Kwun Tong Line Extension (KTE)

Landscape and Visual Plan
Part 2: Gascoigne Road Rest Garden
(August 2015) – Revision C (November 2017)

Response to Comments

MTR Kwun Tong Line Extension- Gascoigne Road Rest Garden - Revision B (August 2016) EP Condition 4.9 - Landscape and Visual Plan

DRAWING NO. 1001/W/HOM/OAP/A58/152 REV. E 1

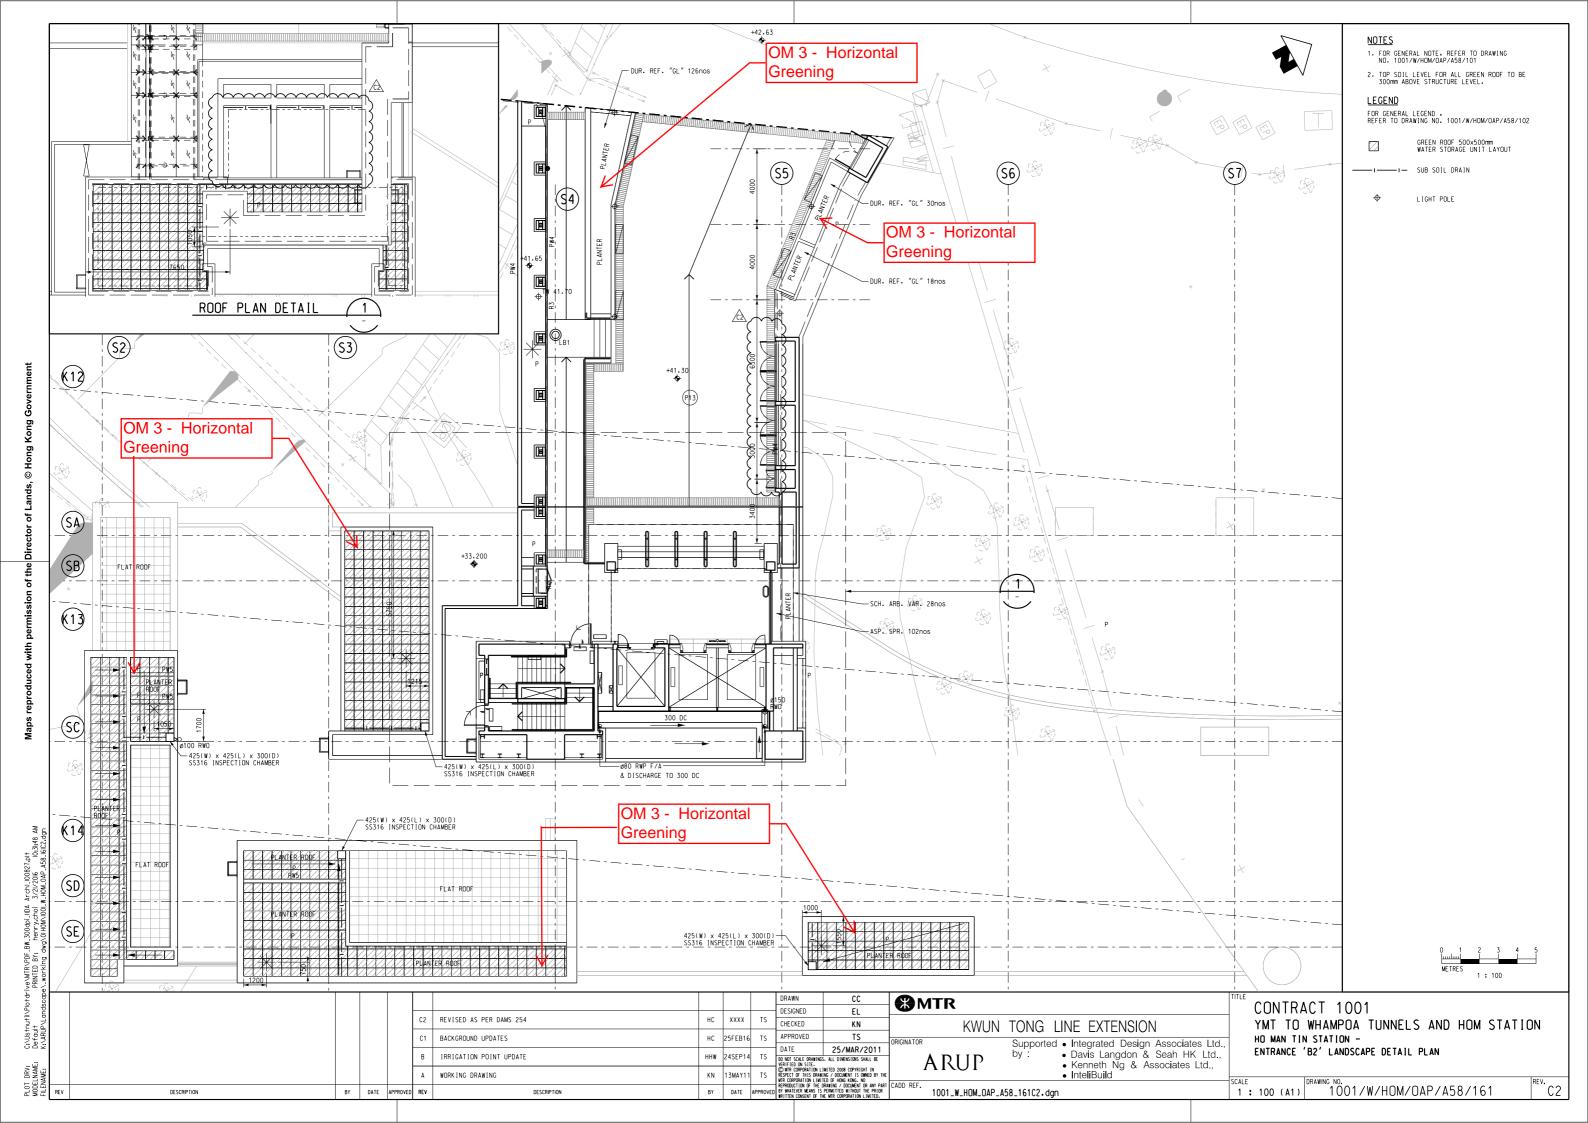
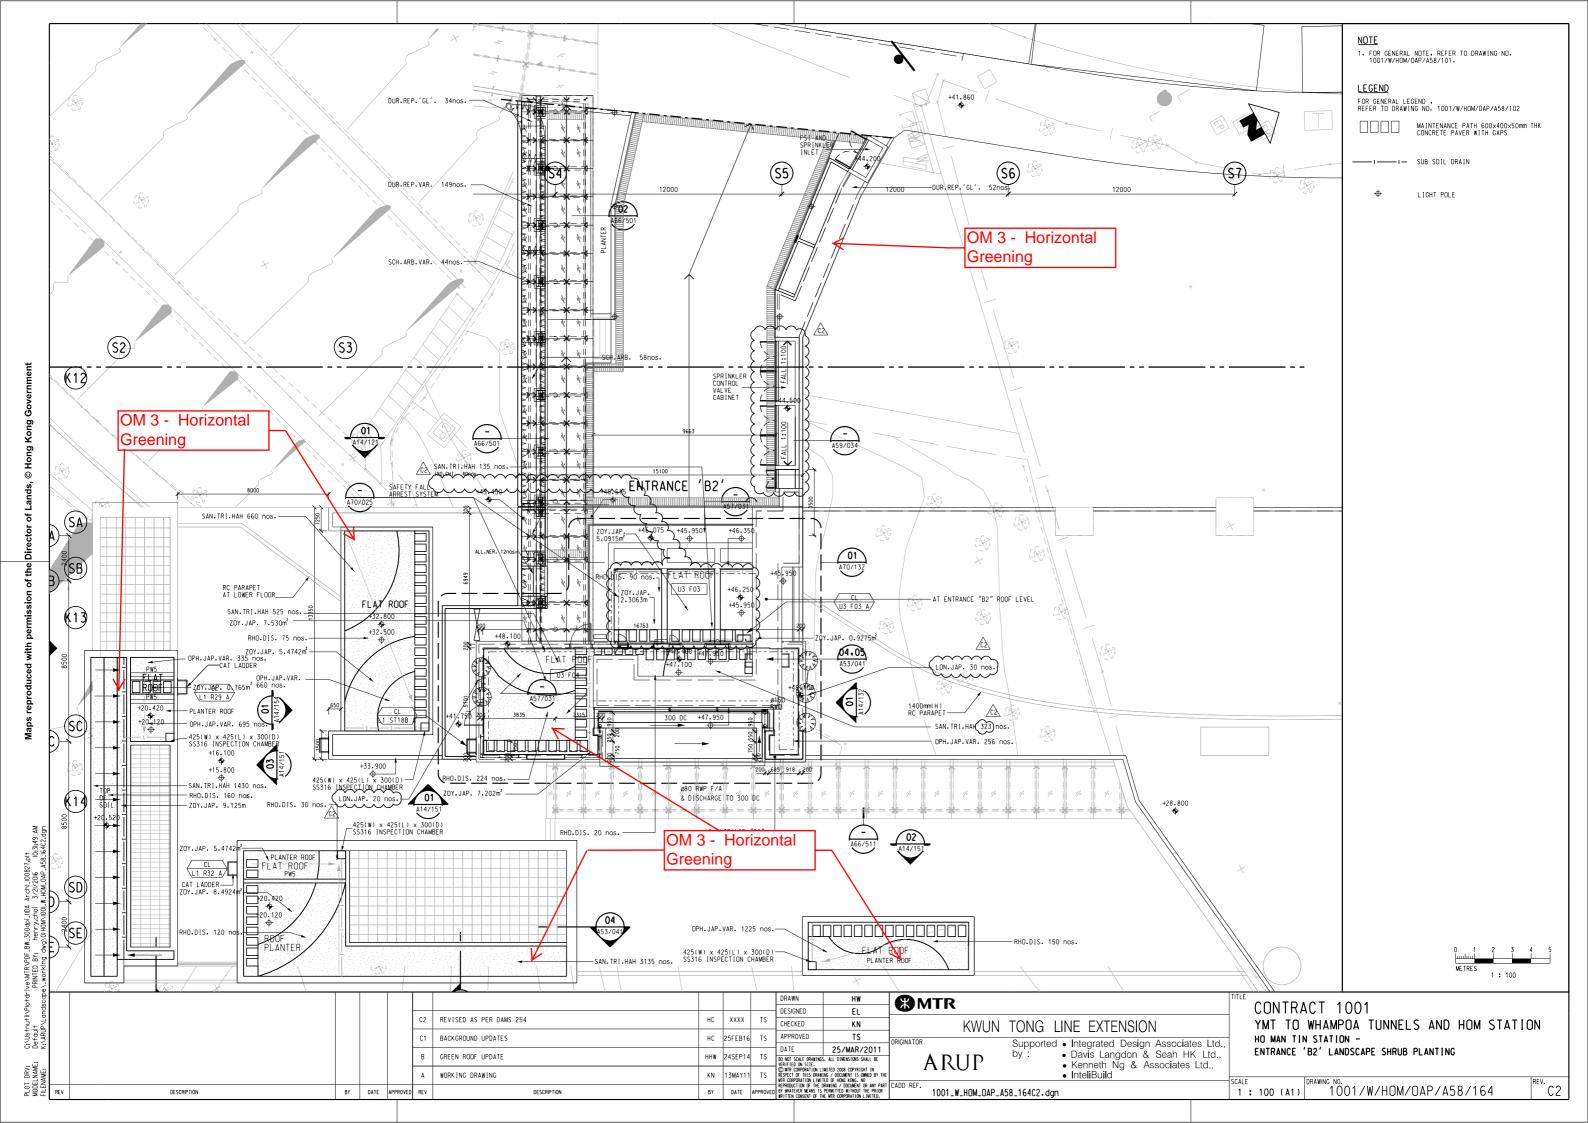
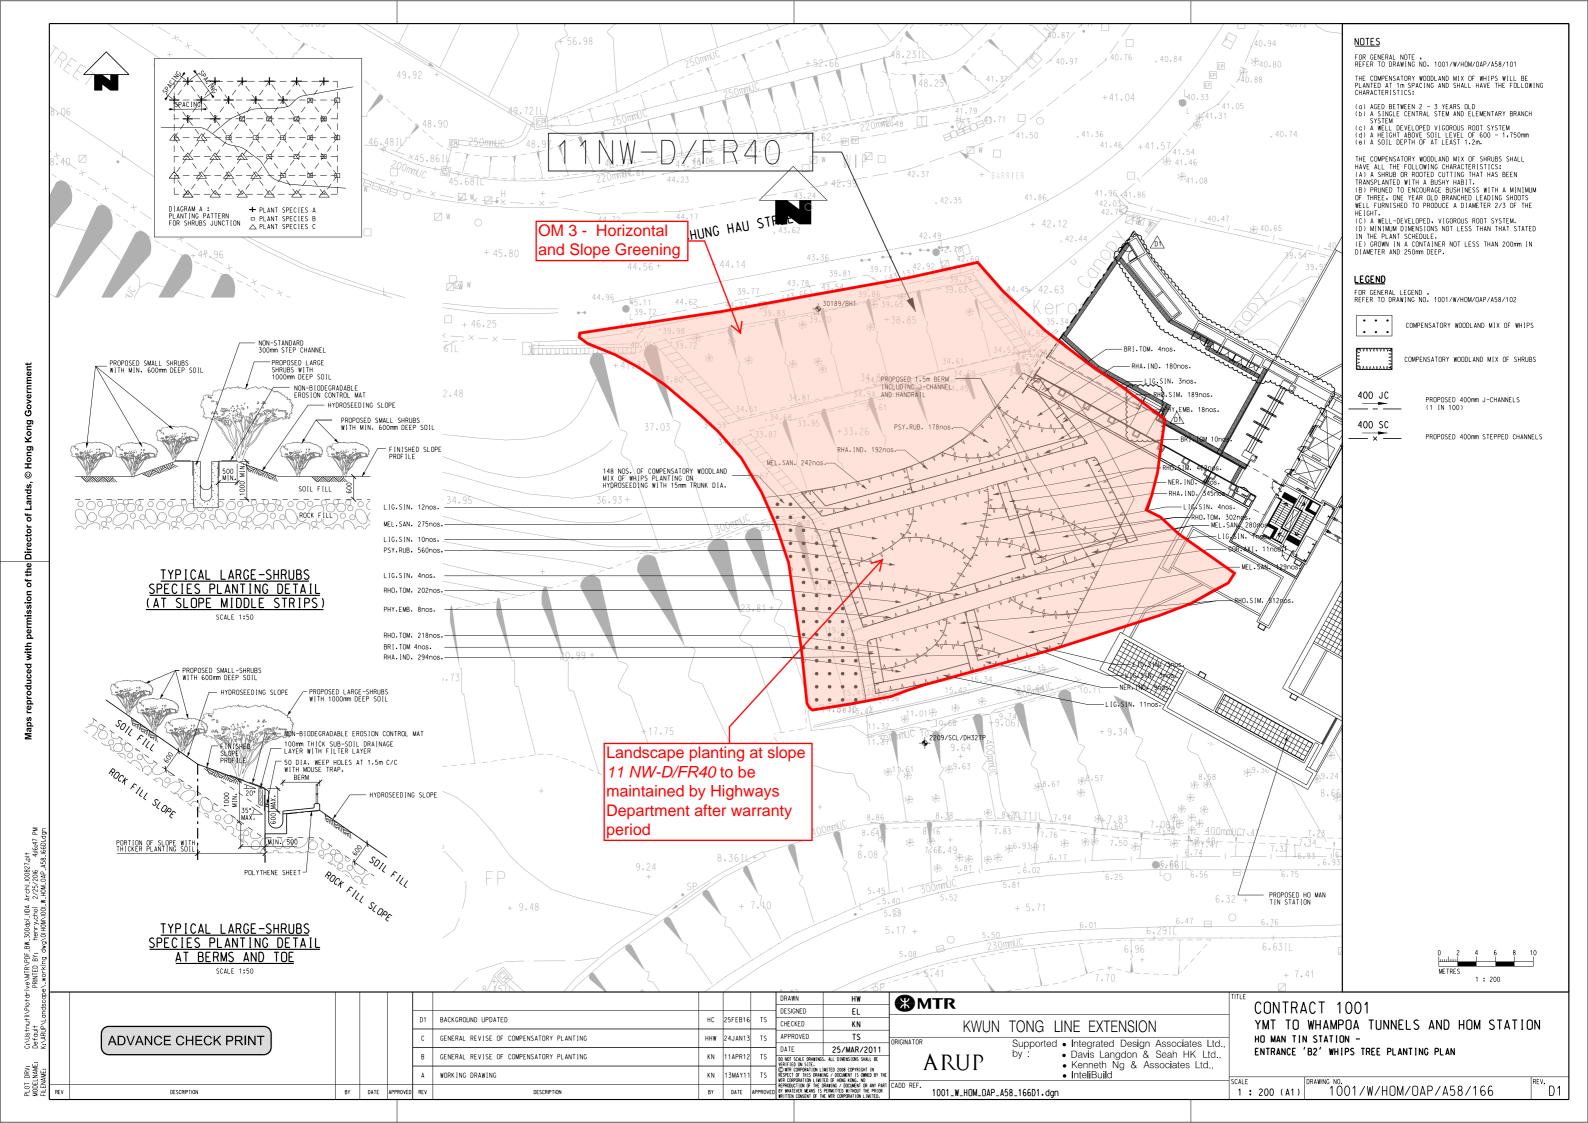
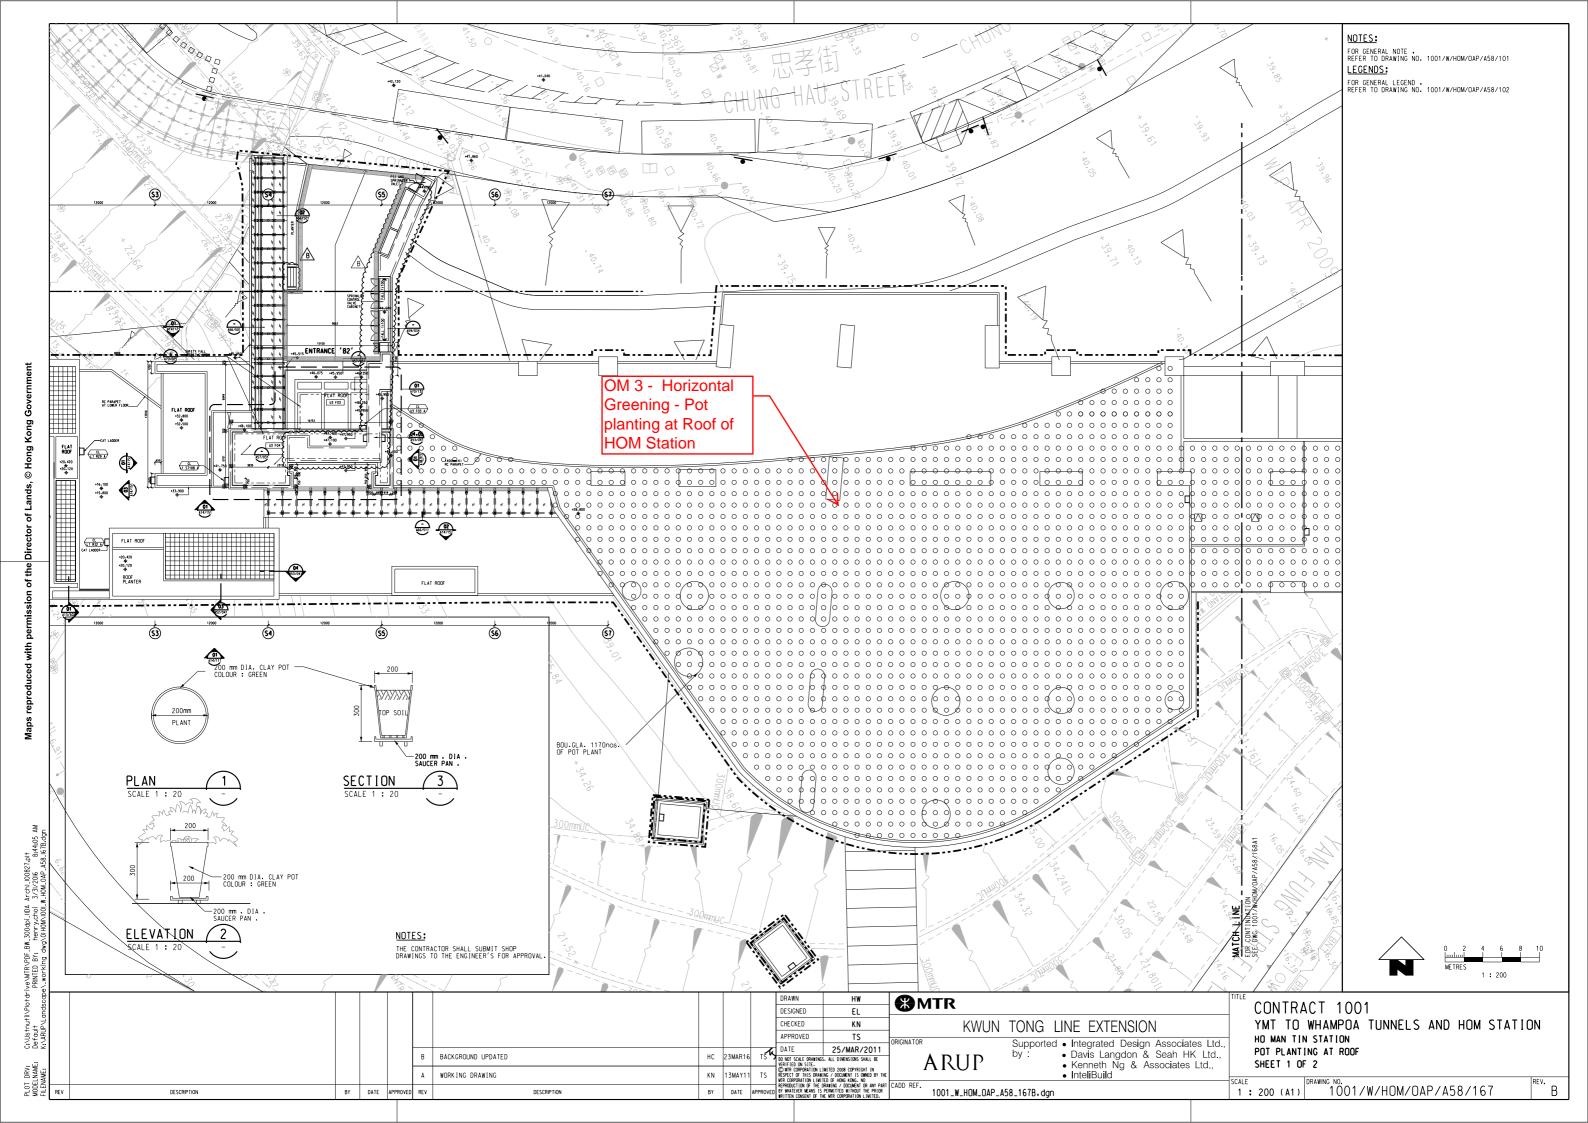
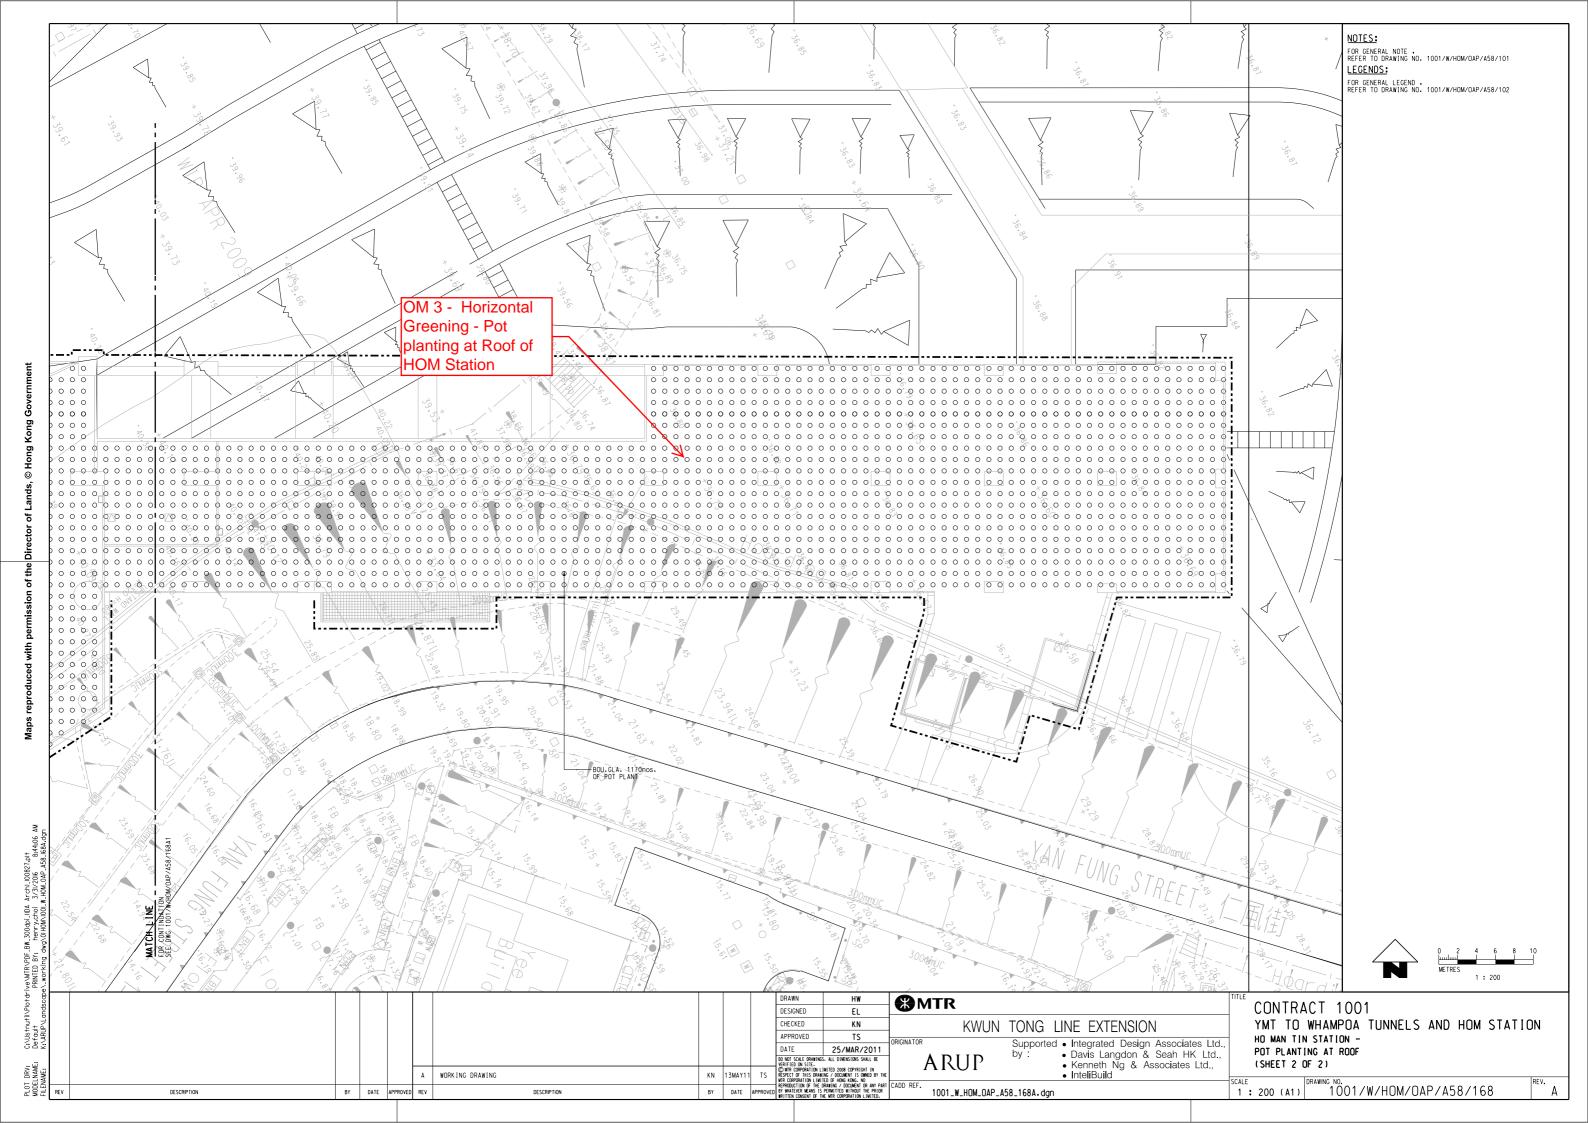
14.			m	OM4 (Vertical green): The proposed climber species noted in the planting schedule are species with clinging habit. However, the details of the supporting frames for the proposed species are not submitted. The proposed vertical green, as high as 10m ht., is in doubt. In addition, it is presumed that the proposed vertical green is to mitigate the impact of retaining structure on slopes. Climber species with self-adhesive habit is preferred.	Supporting metal frames have been provided for façade with vertical greening and photos in Appendix B refer. The climbers' species are Lonicera Japonica and Pyrostegia Venusta which have been provided in Planting Plan Schedule (100/W/HOM/OAP/A58/152).

18.			q	OM4 (Vertical green): Please refer to our comment on LDR 3.2.	Supporting metal frames have been provided for façade with vertical greening and photos in Appendix B refer. The climbers species are Lonicera Japonica and Pyrostegia Venusta which have been provided in Planting Plan Schedule (100/W/HOM/OAP/A58/152).

24.			W	OM4 (Vertical green): Please refer to our comment on LDR 3.2.	Supporting metal frames have been provided for façade with vertical greening and photos in Appendix X refer. The climber's species are Lonicera Japonica and Pyrostegia Venusta which have been provided in Planting Plan Schedule (100/W/HOM/OAP/A58/152).

28.			aa	The proposed Type C1 green climbers should be specified for comments.	The climber's species are Lonicera Japonica and Pyrostegia Venusta which have been provided in Planting Plan Schedule (100/W/HOM/OAP/A58/152).
